SERVICE BULLETIN

Bulletin Part Number: 787930-B1

Product: S1 Pro

Subject: Battery Drain Rework

Figure 1

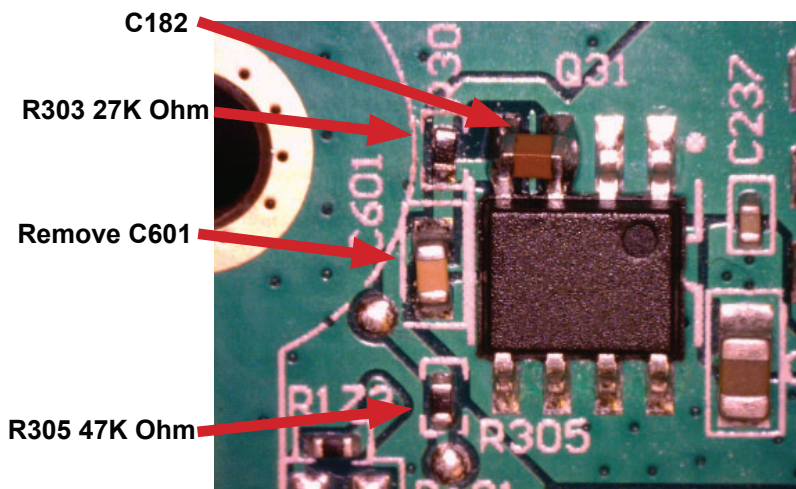
Symptom: The Battery may drain when the S1 Pro is unplugged from AC Mains.

Reason: Q31 is defective.

1. Remove the battery if installed.
2. Remove C601.
3. Replace: Q31 MOSFET, part number: 847949-0010.
4. Replace R303 with a 27K OHM, part number: 801703-2702F.
5. Replace R305 with a 47K OHM, part number: 801703-4702F.
6. Install C182 across pins 3 and 4 shown in figure 1, 1.0uF, 50V capacitor, part number: 770764-105K1H .
Figure 2 shows the rework schematic.
